Project: BVLGARI HOTEL - 100 21st St. Miami Beach, Florida 33139

Plan Correction Report Matrix HPB20-0442

HPB Comments 2021m02d26 FIRST CAP

MATERIAL BOARD
Sheet No.

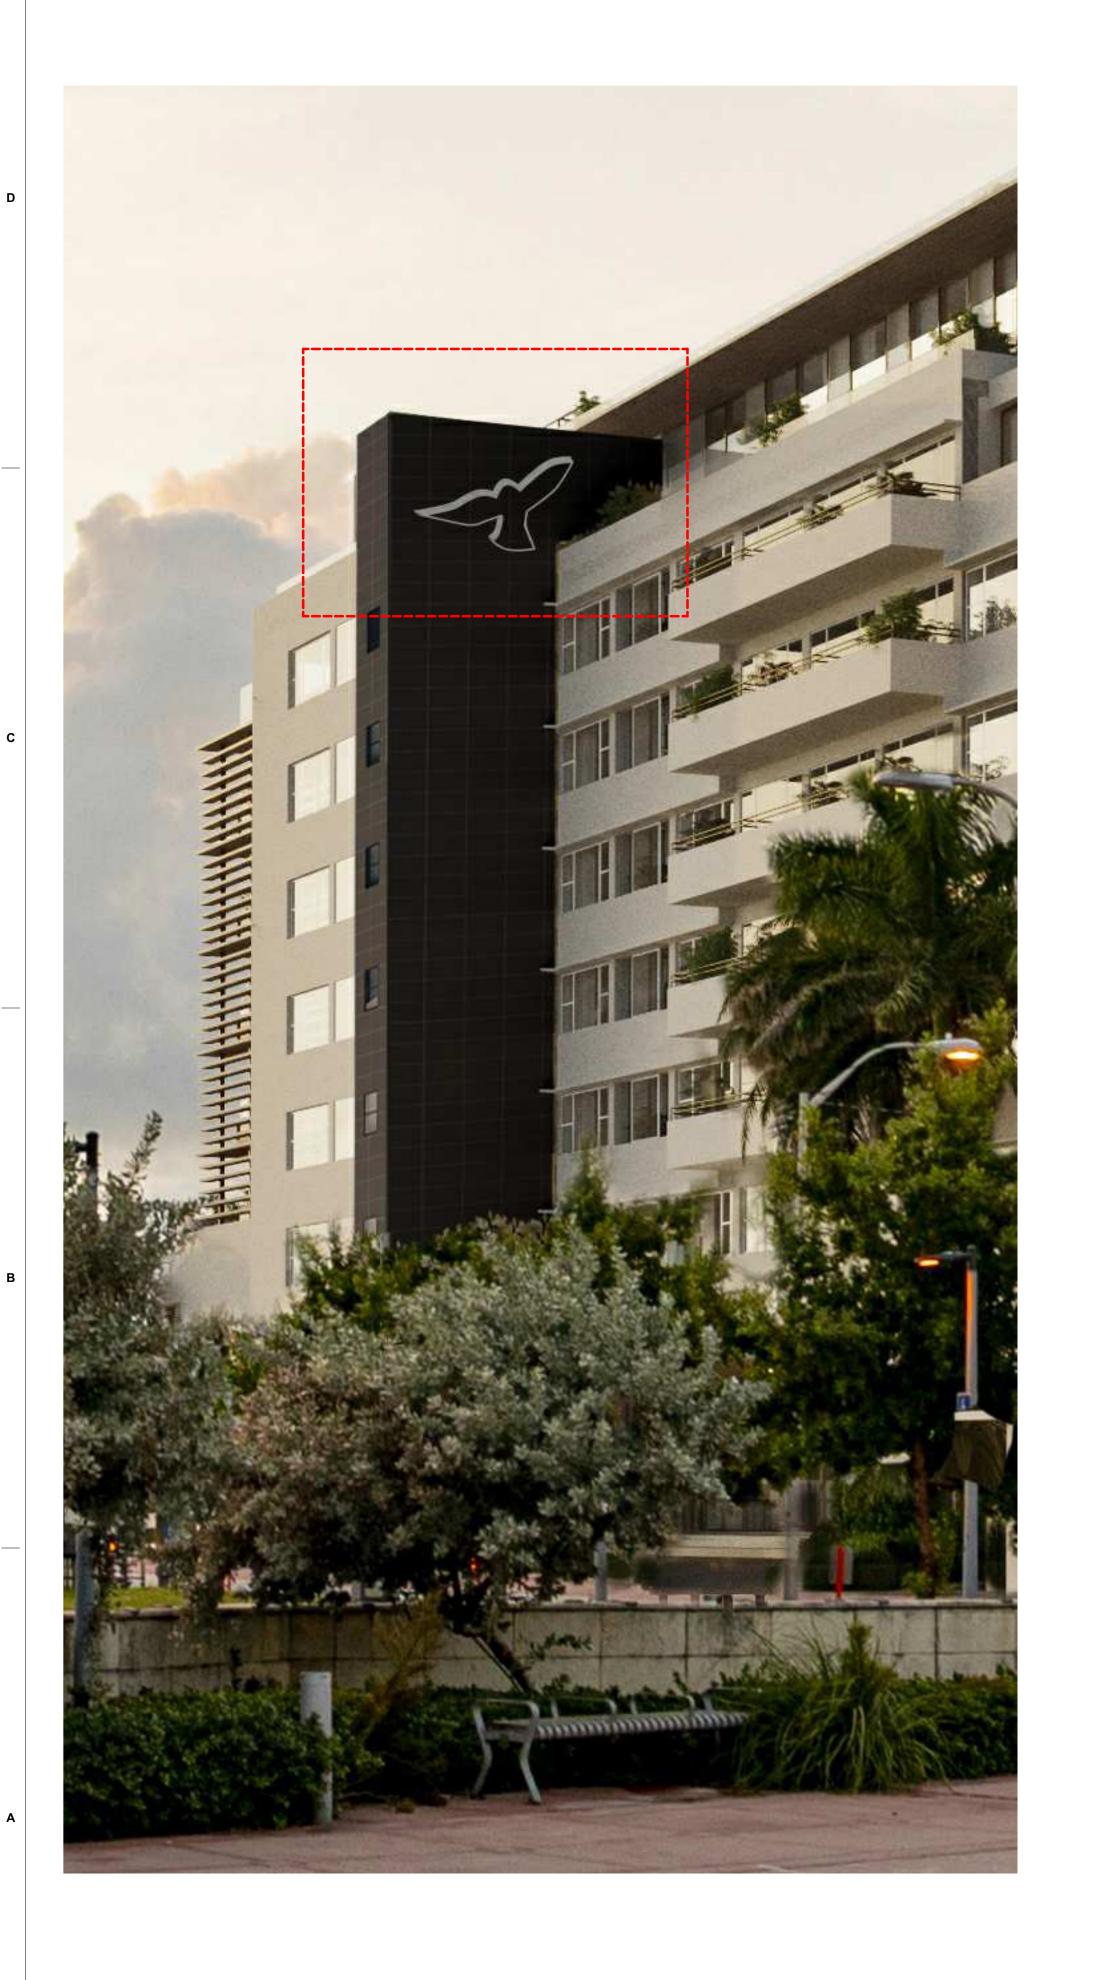
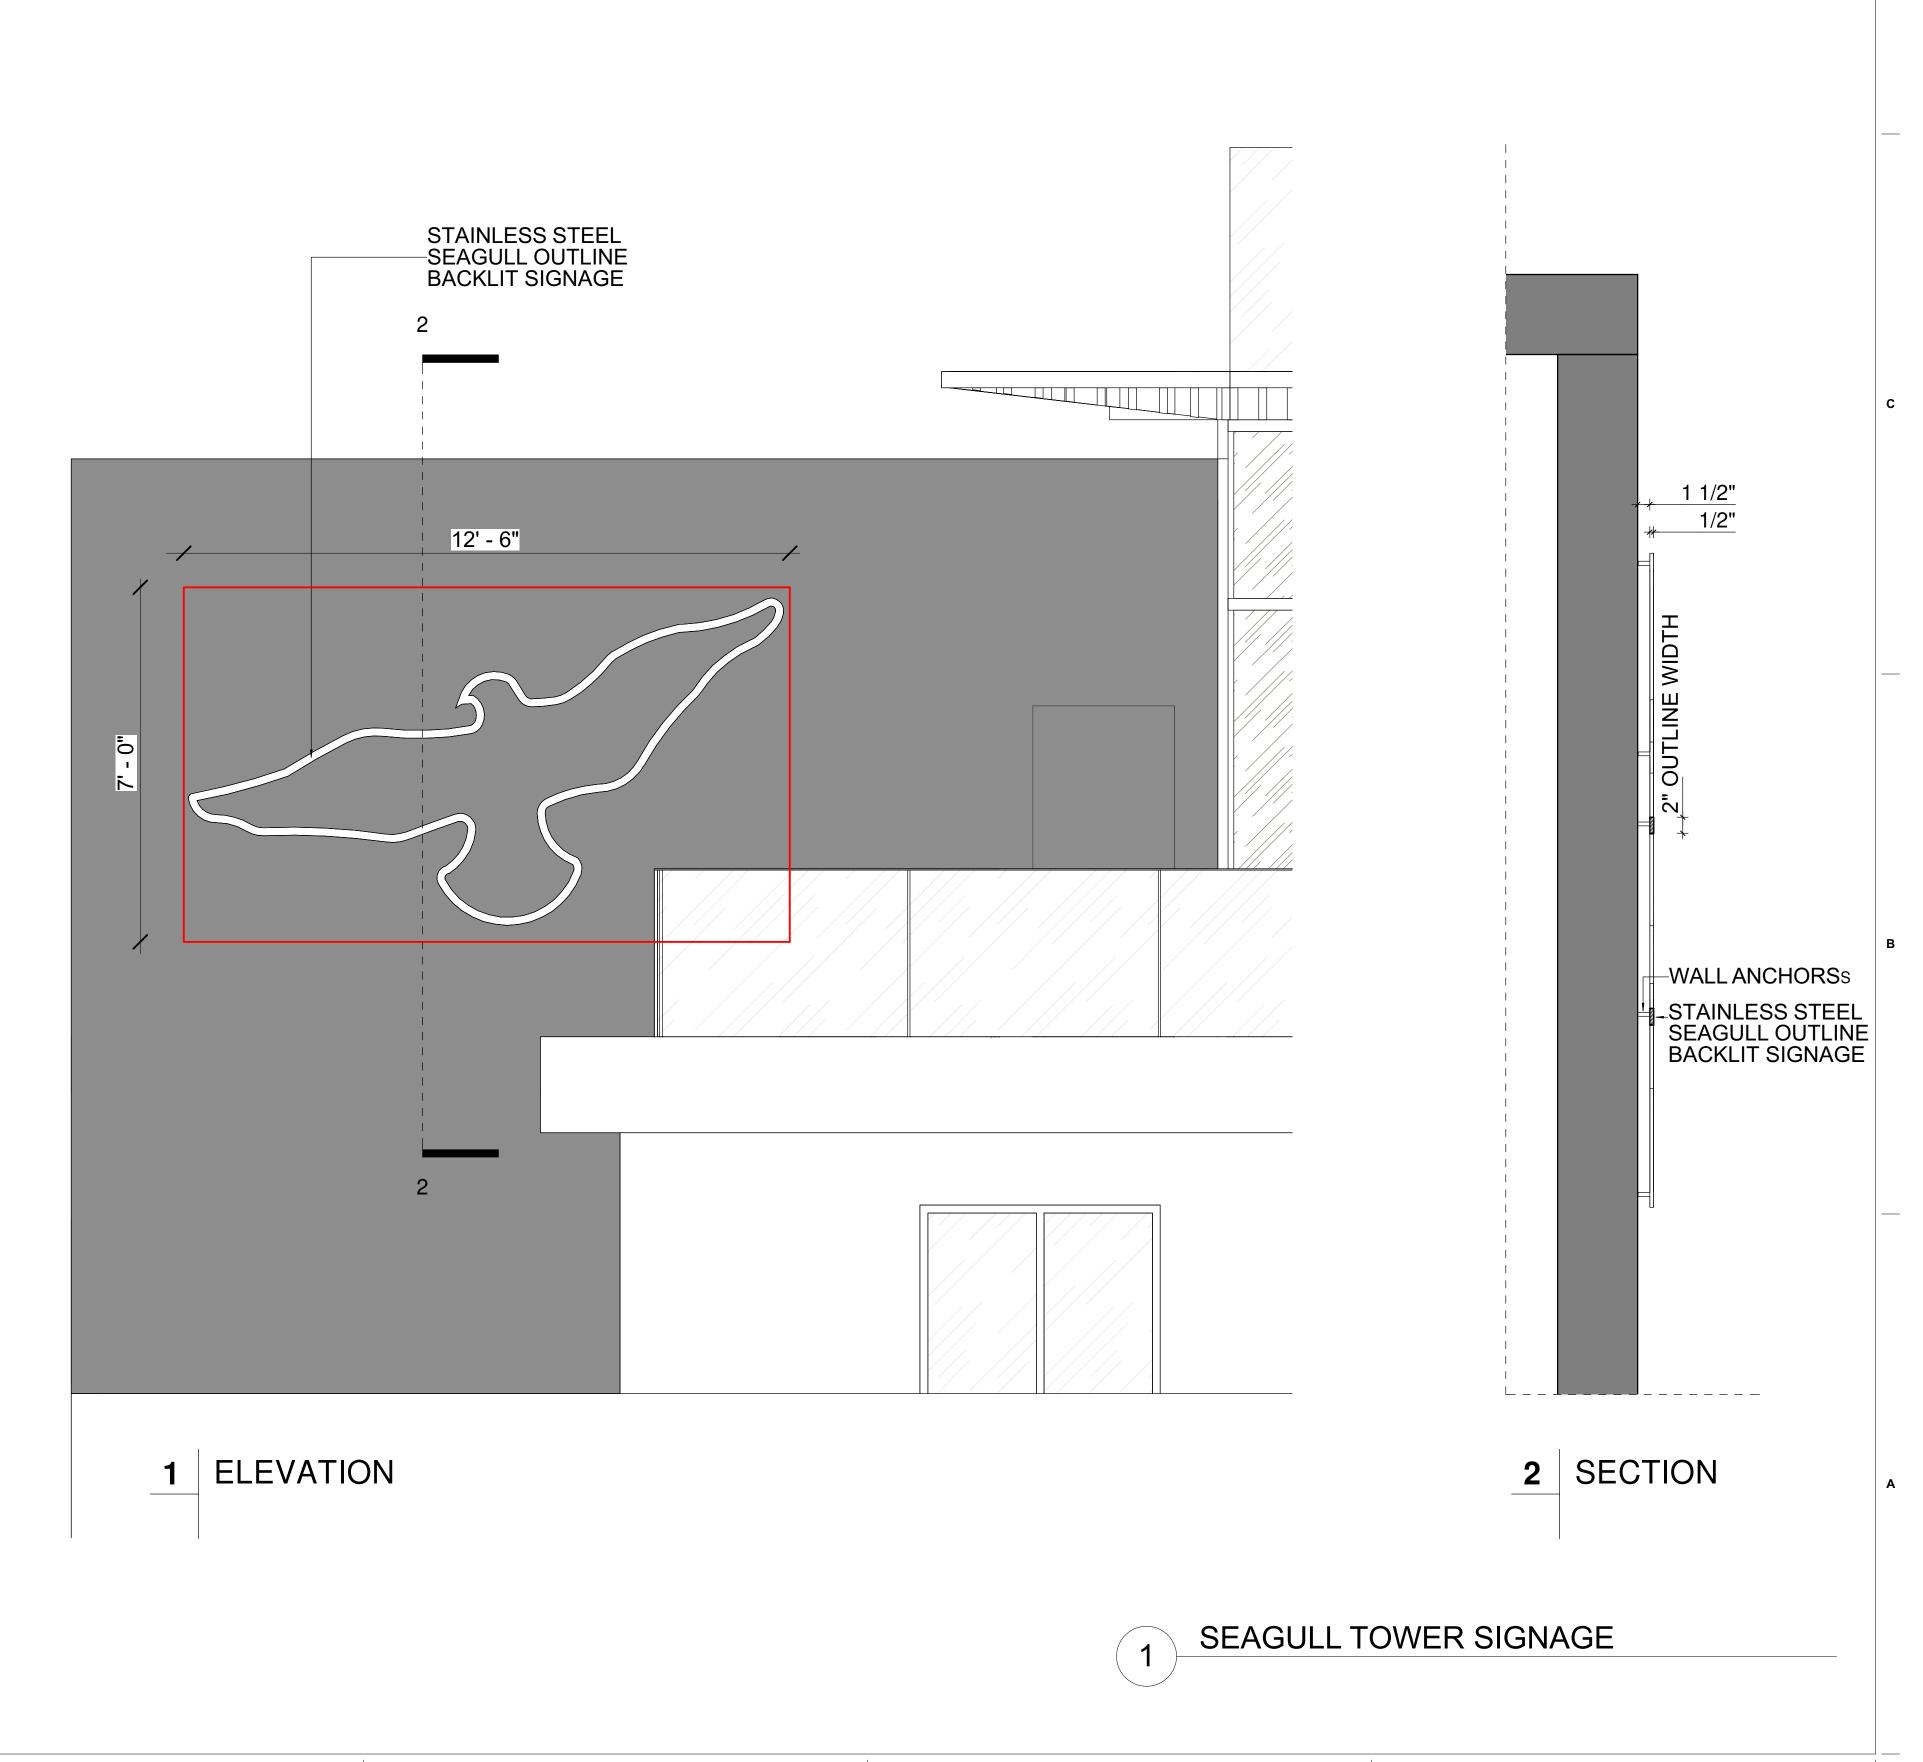
0. HPB Plan I			
	Comments: First Submittal: December 14, 2020 Comments: First Submittal: January 19, 2021		1
	Comments Issued: January 29, 2021		
	Comments Issued: February 26, 2021		
1	James Seiberling Ph: email: JamesSeiberling@miamibeachfl.gov DEFICIENCIES IN PRESENTATION		
a		The gold glass mosaic was mistakenly carried from the previous application, no gold mosaic is	
	unknown. Please clarify. Provide close up photos of existing tower cladding material.		
u	full known. Flease claimy. Frovide close up photos of existing tower cladding material.	being proposed.	
u .	Turknown. Flease clarity. Frovide close up priotos of existing tower clauding material.	The tiled tower element adjacent to the main entry of the building is an important and prominent	
u	dirknown. Flease clamy. Frovide close up photos of existing tower clauding material.	The tiled tower element adjacent to the main entry of the building is an important and prominent feature of the building. The original dark tile finish has been painted over at least twice in the

u	uliknown. Flease clamy. Frovide close up photos of existing tower clauding material.	The tiled tower element adjacent to the main entry of the building is an important and prominent feature of the building. The original dark tile finish has been painted over at least twice in the intervening period; first to a lime green colour and most recently in a light grey colour. In all cases the finish applied to the vertical wall has contrasted with the white stucco which characterizes the	
u	uliknown. Flease clamy. Frovide close up photos of existing tower clauding material.	The tiled tower element adjacent to the main entry of the building is an important and prominent feature of the building. The original dark tile finish has been painted over at least twice in the intervening period; first to a lime green colour and most recently in a light grey colour. In all cases the finish applied to the vertical wall has contrasted with the white stucco which characterizes the building drawing emphasis to the verticality of the element. The current design proposal is either to retain the existing tiles if they are revealed to be in a

The tiled tower element adjacent to the main entry of the building is an important and prominent feature of the building. The original dark tile finish has been painted over at least twice in the intervening period; first to a lime green colour and most recently in a light grey colour. In all cases the finish applied to the vertical wall has contrasted with the white stucco which characterizes the building drawing emphasis to the verticality of the element. The current design proposal is either to retain the existing tiles if they are revealed to be in a satisfactory condition or in the other case propose a similar alternative.	Δ_0.36
b c	Seagull historical signage element: provide additional details. It is not clear what is being proposed. For requested variance: provide enlarged drawings of the proposed BVLGARI signage. Provide building id	The tiled tower element adjacent to the main entry of the building is an important and prominent feature of the building. The original dark tile finish has been painted over at least twice in the intervening period; first to a lime green colour and most recently in a light grey colour. In all cases the finish applied to the vertical wall has contrasted with the white stucco which characterizes the building drawing emphasis to the verticality of the element. The current design proposal is either to retain the existing tiles if they are revealed to be in a	A-036 A-038

WEST ELEVATION - SIGNAGE SCALE: 1/16" = 1'-0"

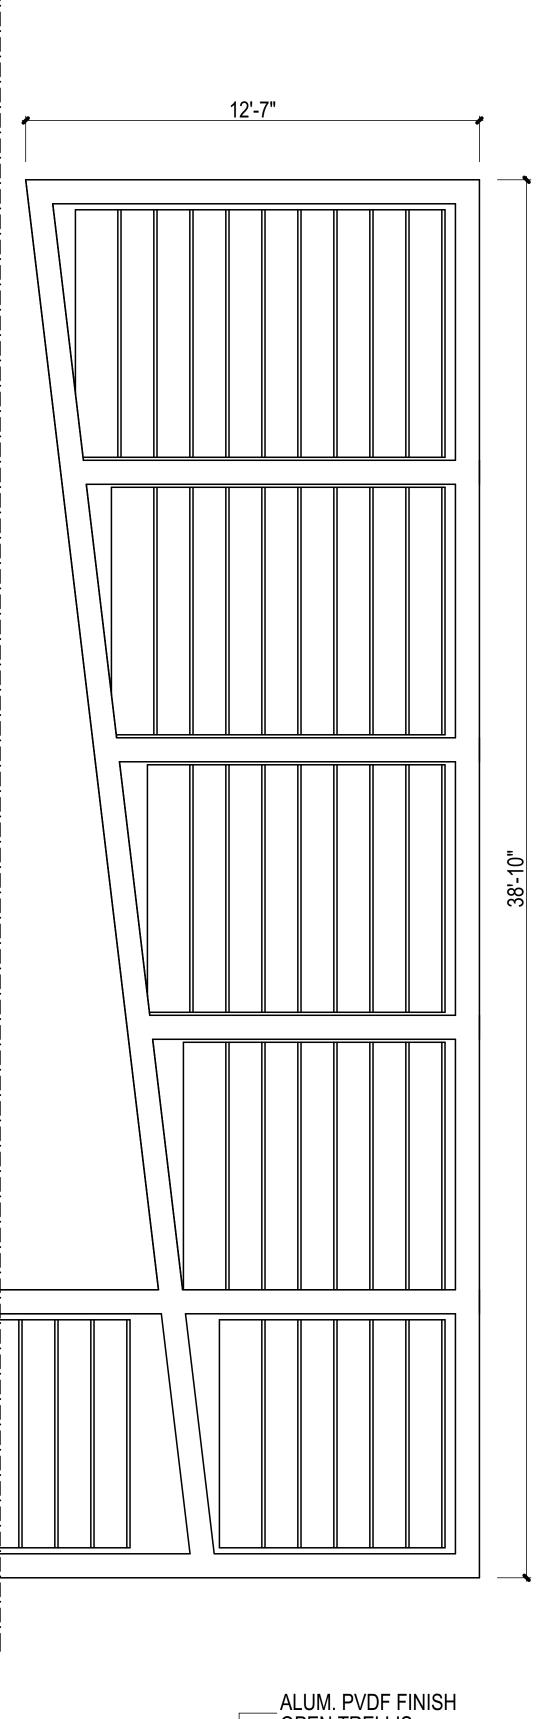
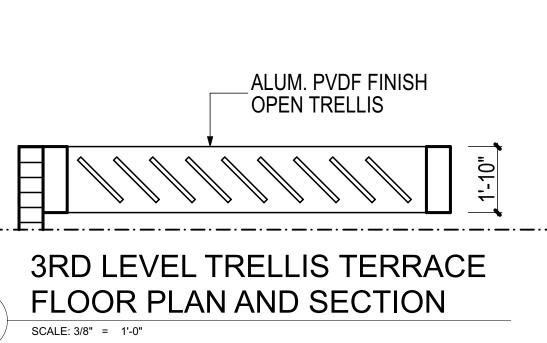
HPB Comments	Response	Reference Sheet
	Review - Fail		
	Comments issued on Dec 24 2020		
	Comments issued on Jan 29 2021 Comments issued on Feb 26 2021		
1	Provide and elevation drawing showing area calculation of the west façade to show compliance with maximum 1%	West façade Elevation Calculation has been added	A-038
	of the area of the façade to install the building id sign.		
2	Provide details and specifications of the building id sign.	The Id Signage is black paint outlining the edge of the characters over the Stucco.	A-037
3	Seagull sign requires a waiver. provide dimensions and area of a square/rectangle around the seagull.	Sheet has been revised	A-036
,			
4	Day beds proposed are not considered part of the open space. Final zoning approval for the proposed open space will be subject to new interpretation of required open space in the rear yard, per Michael Belush.	No Day Beds are proposed

b	Seagull historical signage element: provide additional details. It is not clear what is being proposed. For requested variance: provide enlarged drawings of the proposed BVLGARI signage. Provide building id calculation for allowable square footage for the north side (max size is 1% of total wall area). Requesting variance	The tiled tower element adjacent to the main entry of the building is an important and prominent feature of the building. The original dark tile finish has been painted over at least twice in the intervening period; first to a lime green colour and most recently in a light grey colour. In all cases the finish applied to the vertical wall has contrasted with the white stucco which characterizes the building drawing emphasis to the verticality of the element. The current design proposal is either to retain the existing tiles if they are revealed to be in a satisfactory condition or in the other case propose a similar alternative. Sheet has been revised

<u>b</u>	Seagull historical signage element: provide additional details. It is not clear what is being proposed. For requested variance: provide enlarged drawings of the proposed BVLGARI signage. Provide building id calculation for allowable square footage for the north side (max size is 1% of total wall area). Requesting variance to relocate allowable building id sign to west (non-street facing) façade. Staff recommends including reference photos of previous signage on this elevation.	The tiled tower element adjacent to the main entry of the building is an important and prominent feature of the building. The original dark tile finish has been painted over at least twice in the intervening period; first to a lime green colour and most recently in a light grey colour. In all cases the finish applied to the vertical wall has contrasted with the white stucco which characterizes the building drawing emphasis to the verticality of the element. The current design proposal is either to retain the existing tiles if they are revealed to be in a satisfactory condition or in the other case propose a similar alternative. Sheet has been revised West façade Elevation Calculation has been added	A-038
